**NOTICE OF ADDENDUM
 ADDENDUM NO. 1
 CONTRACT NO. 8622, PROJECT NO. 13706
 S. OWEN DRIVE, KEATING TERRACE AND CAROMAR DRIVE
 RESURFACING ASSESSMENT DISTRICT - 2022**

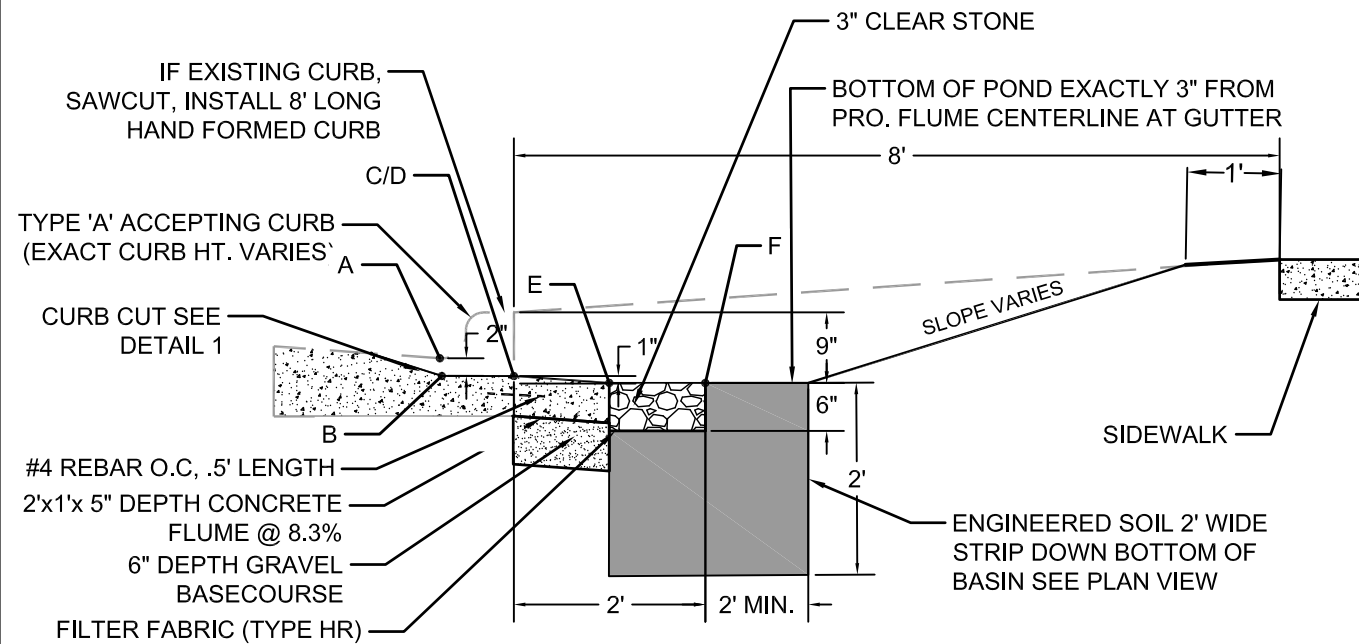
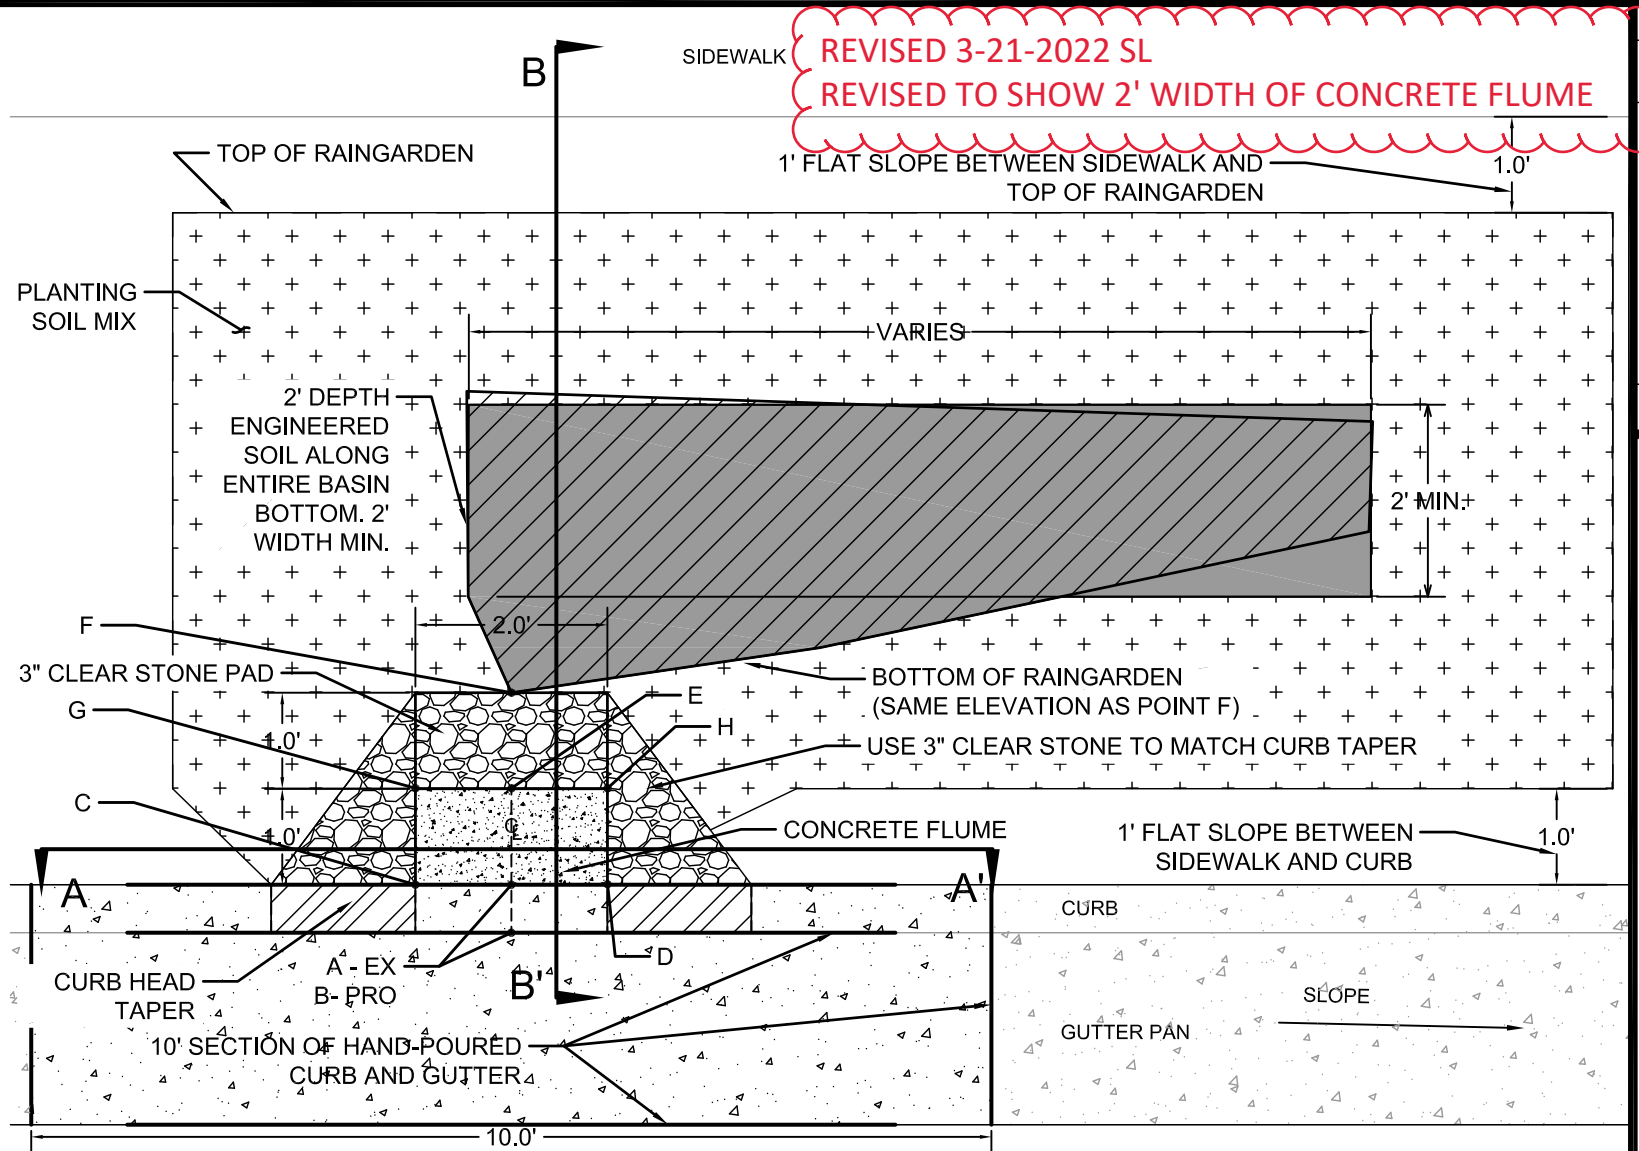
Sheet D-3 is being revised to show the correct dimensions of the concrete flume.
